# **Proposed Marlborough Environment Plan**

**Section 42A Hearings Report for Hearing Commencing**

**Report on submissions and further submissions  
topic: Significant Wetlands**

Photograph 9

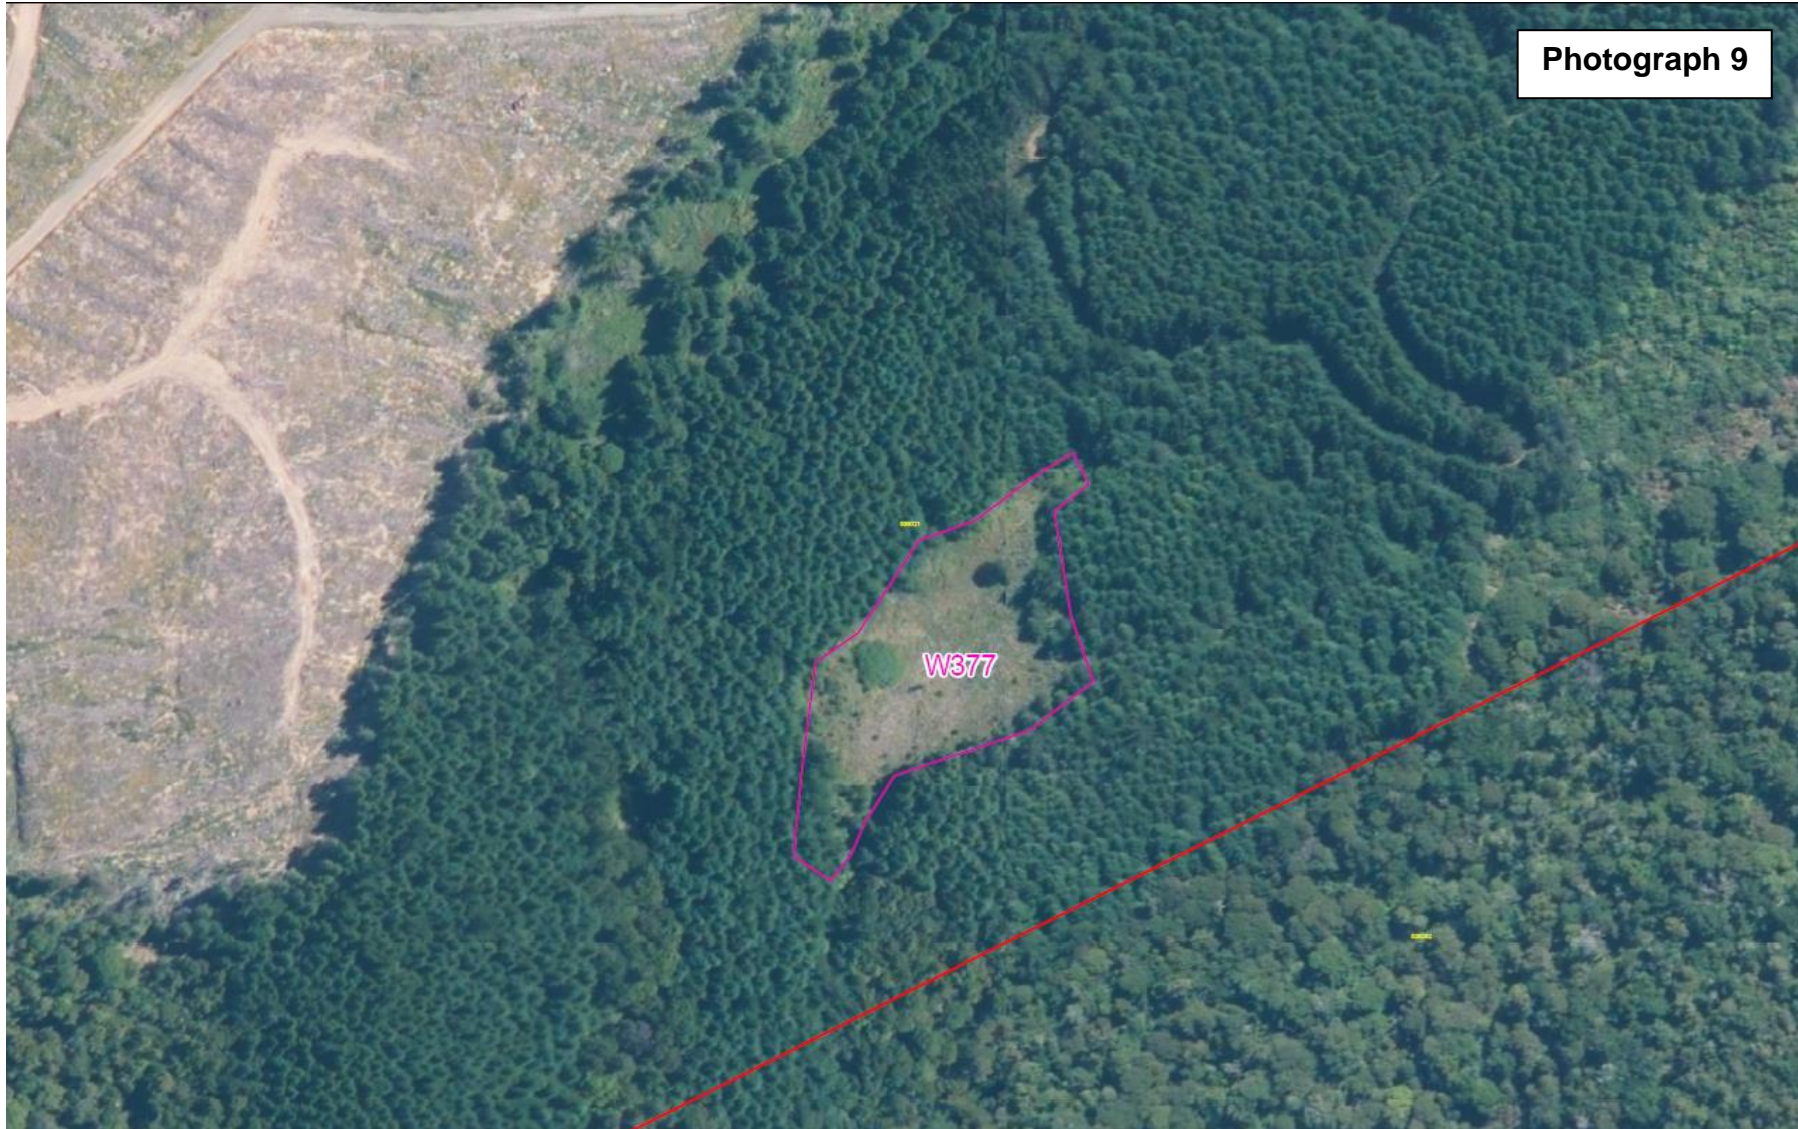
R Farley – Submission Point 134.1

Photograph 15

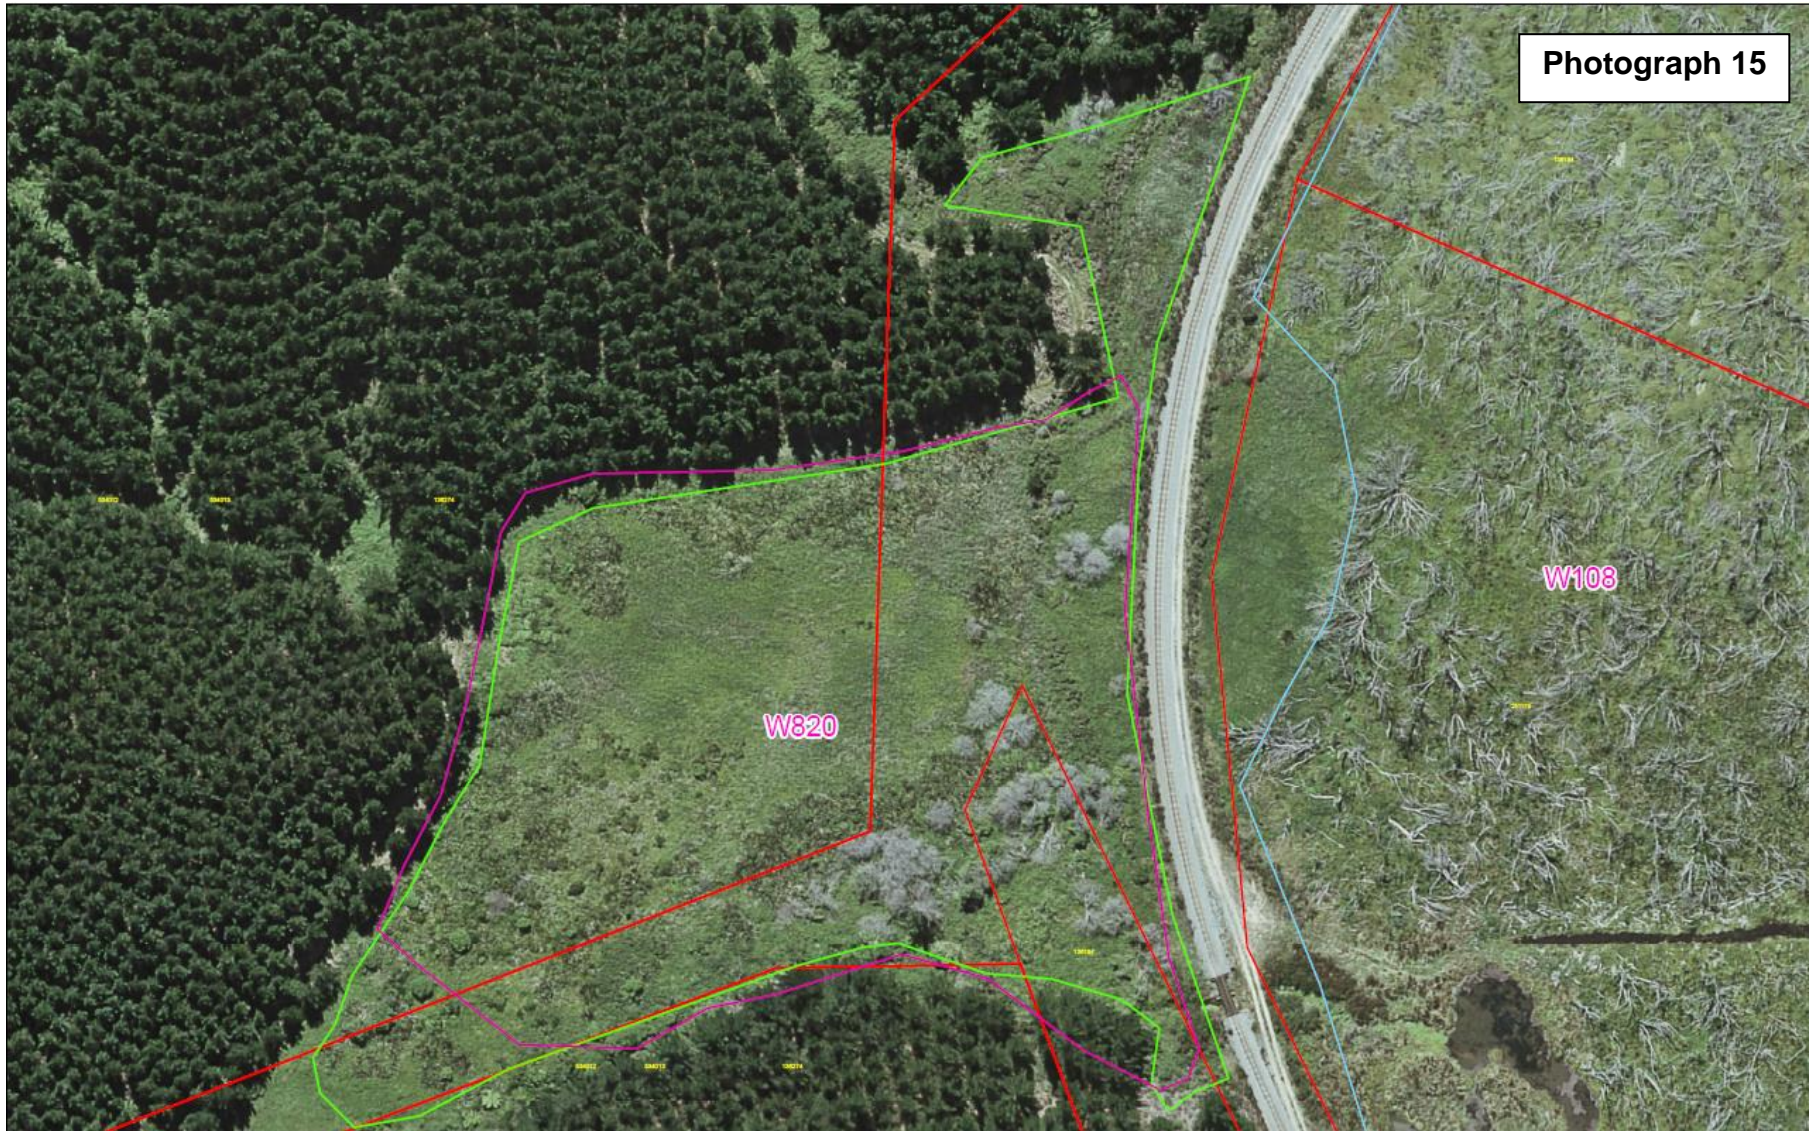
Zoning Map 149 – Windermere Forests Limited – Submission Point 1238.47

Photograph 17

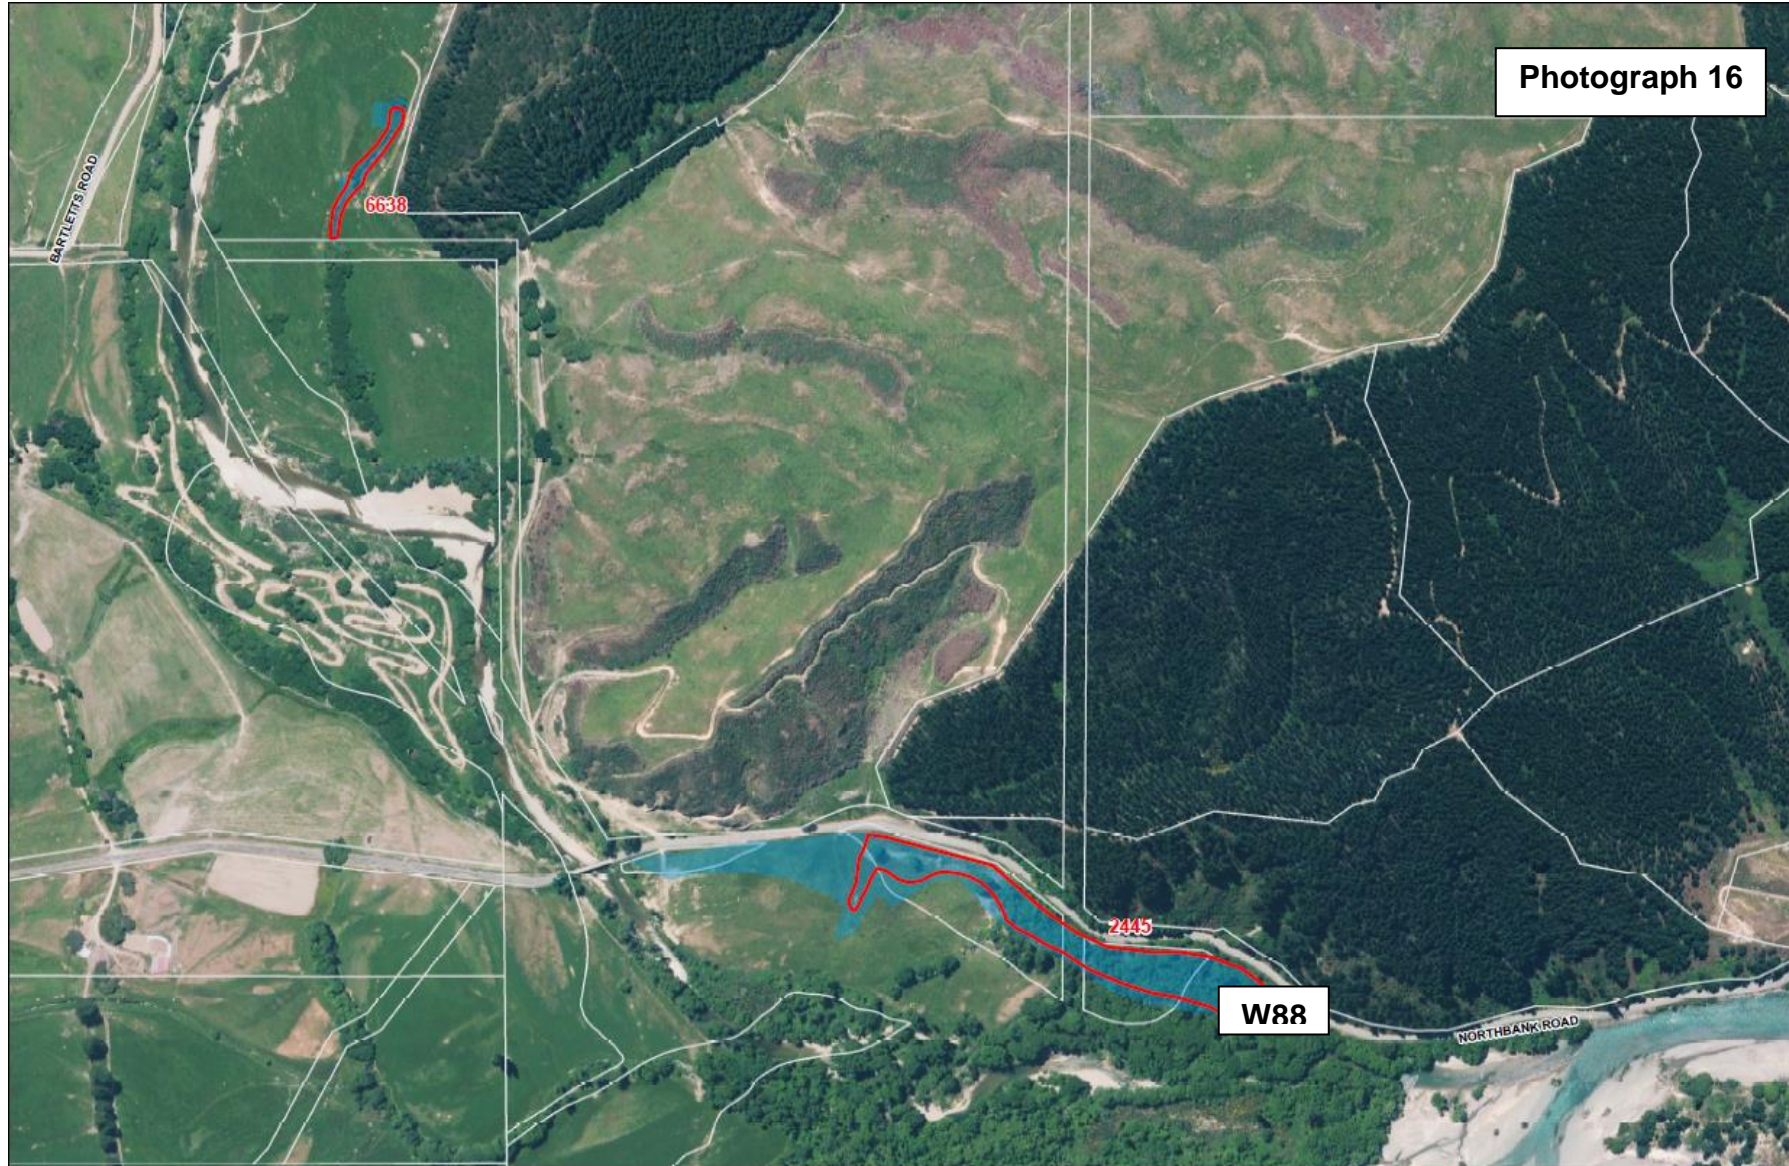
Zoning Map 149 – Windermere Forests Limited – Submission Point 1238.47

Photograph 20

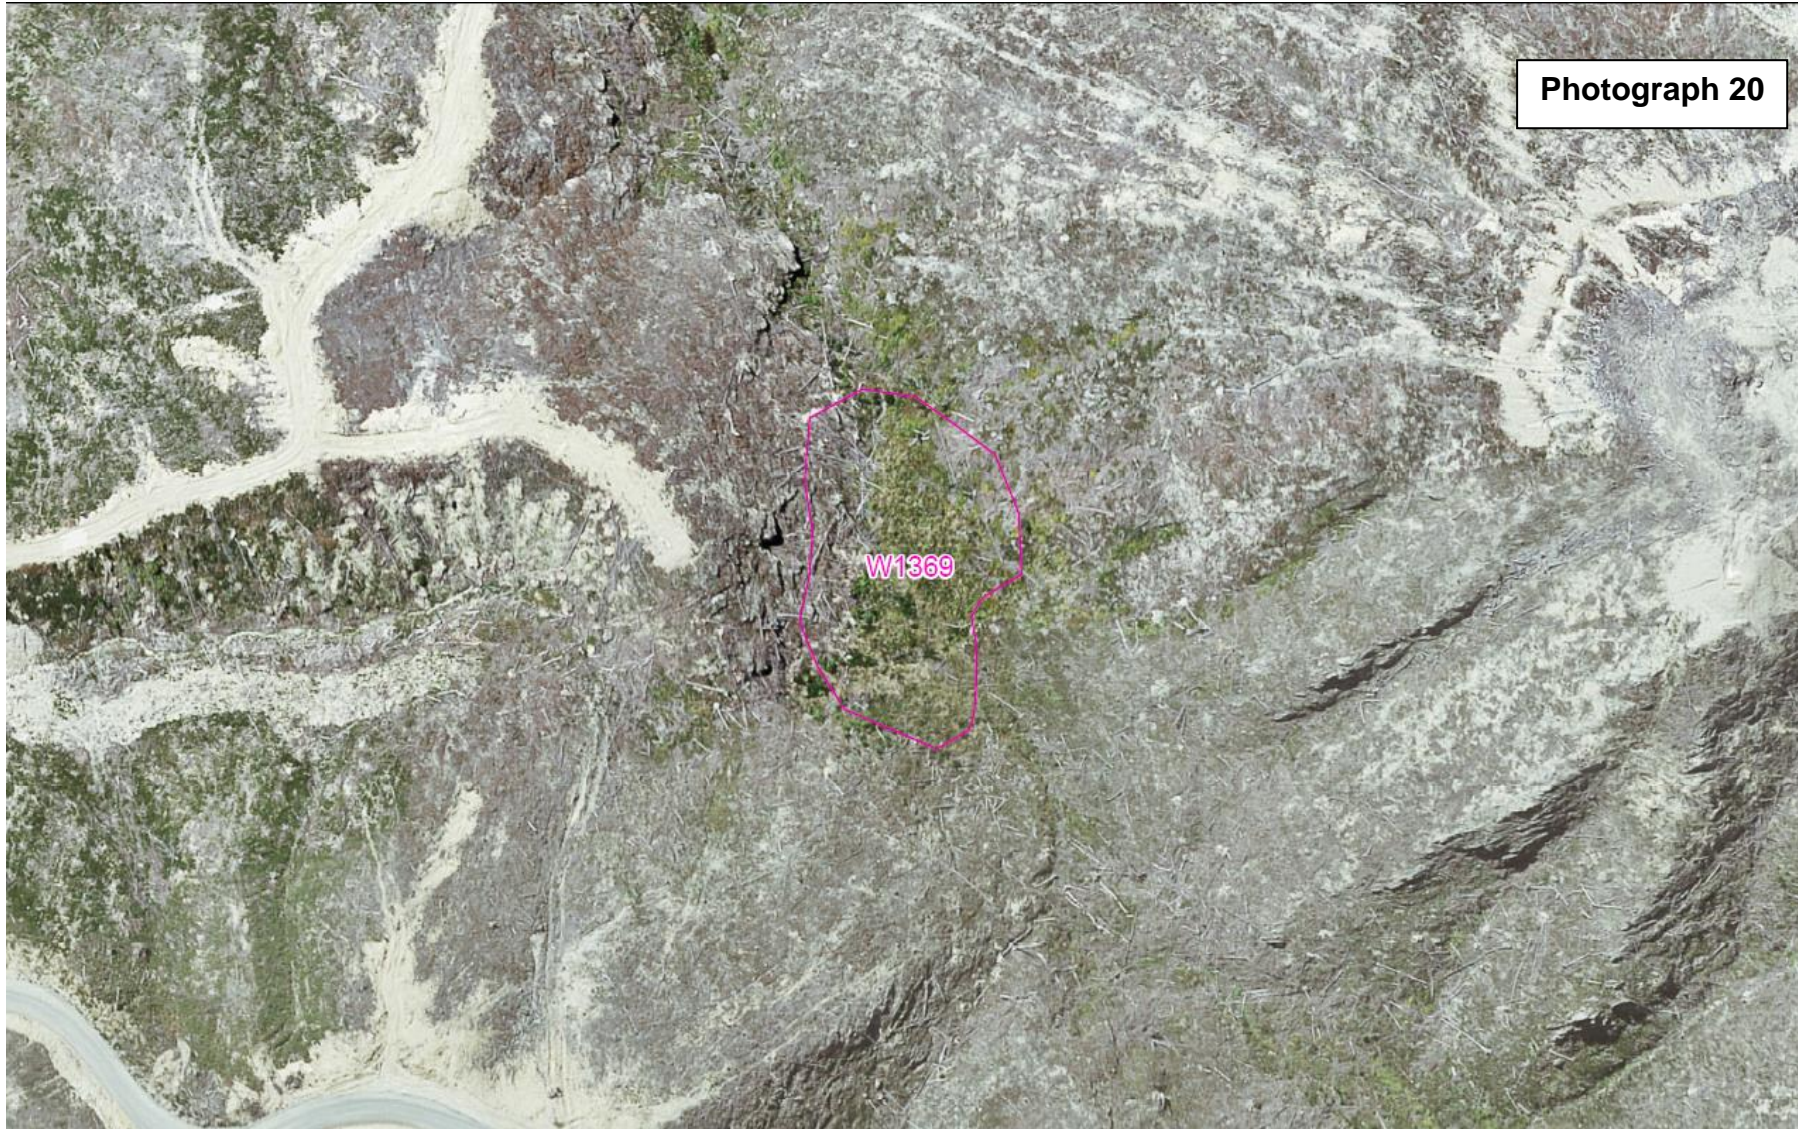
Zoning Map 156 – Nelson Forests Limited – Submission Points 990.60 and 990.205™

Photograph 22

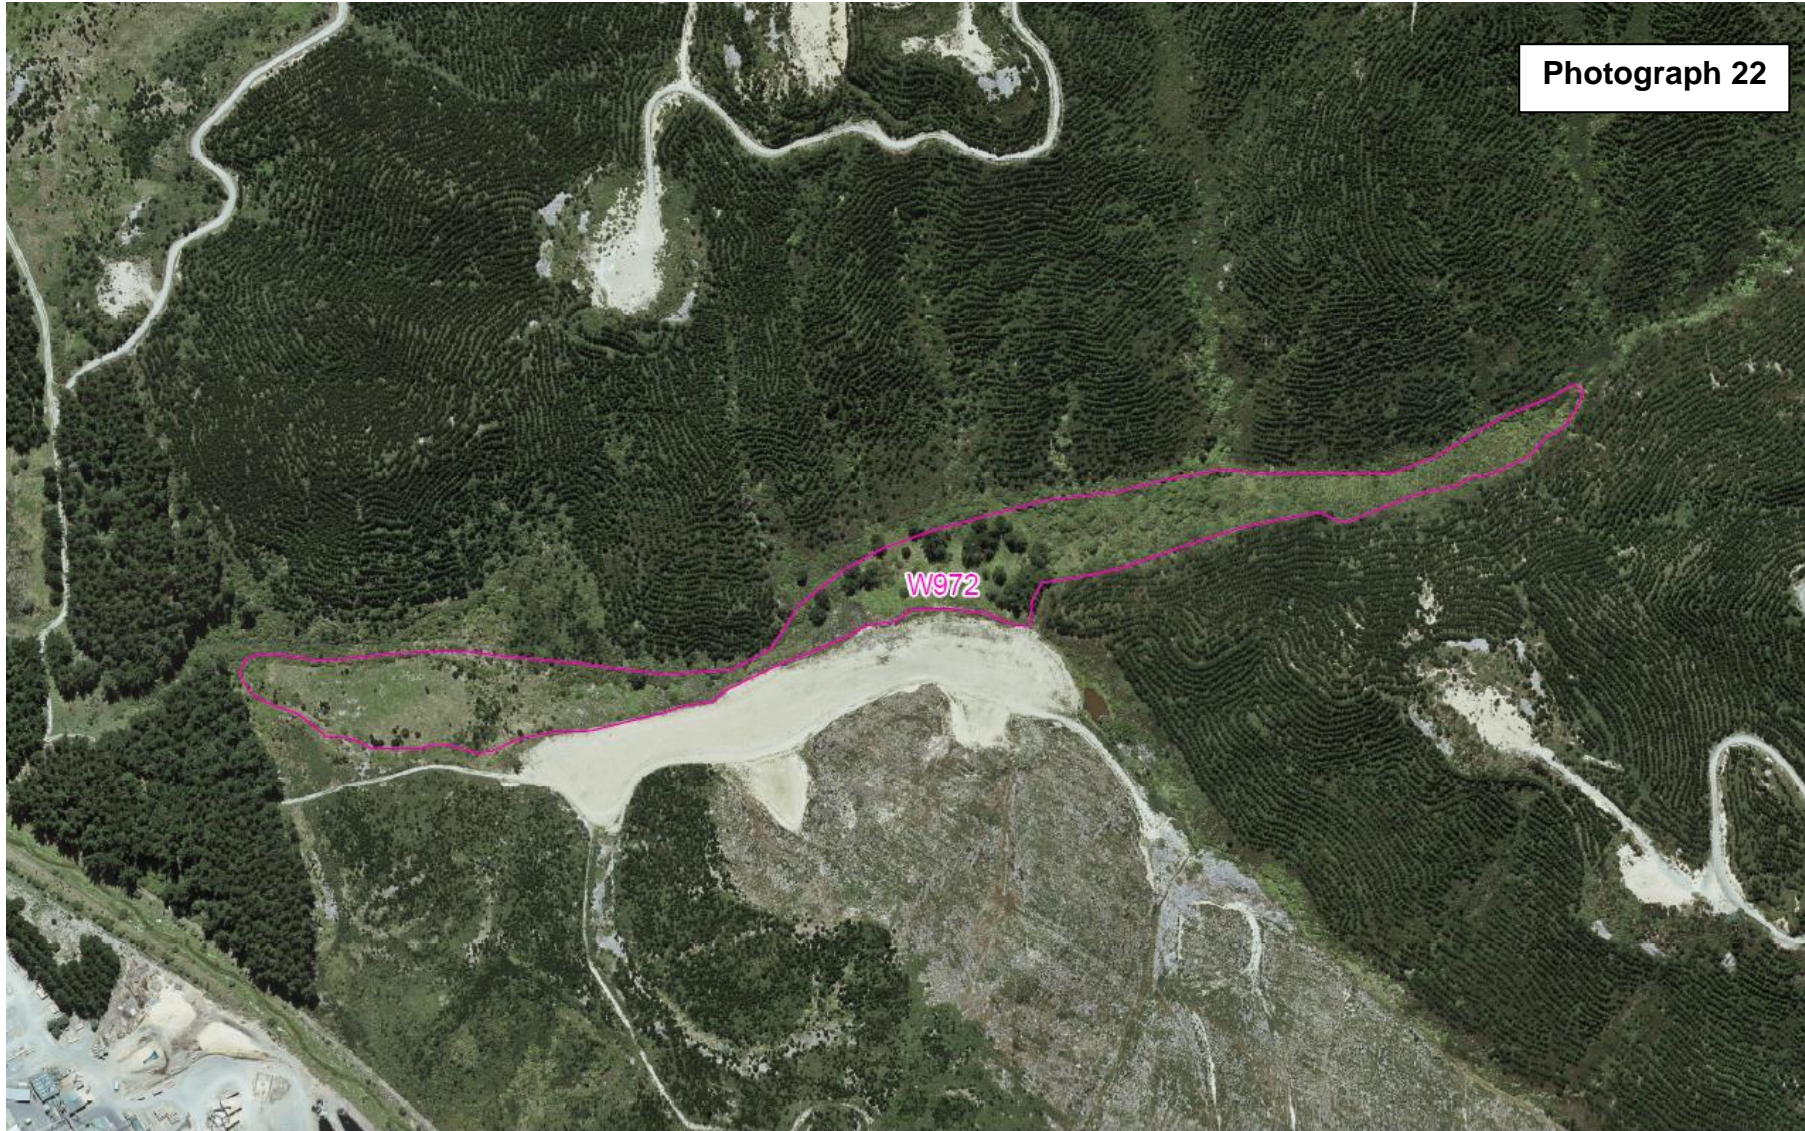
Zoning Map 157 – Nelson Forests Limited – Submission Points 990.59 and 990.206<sup>W</sup>
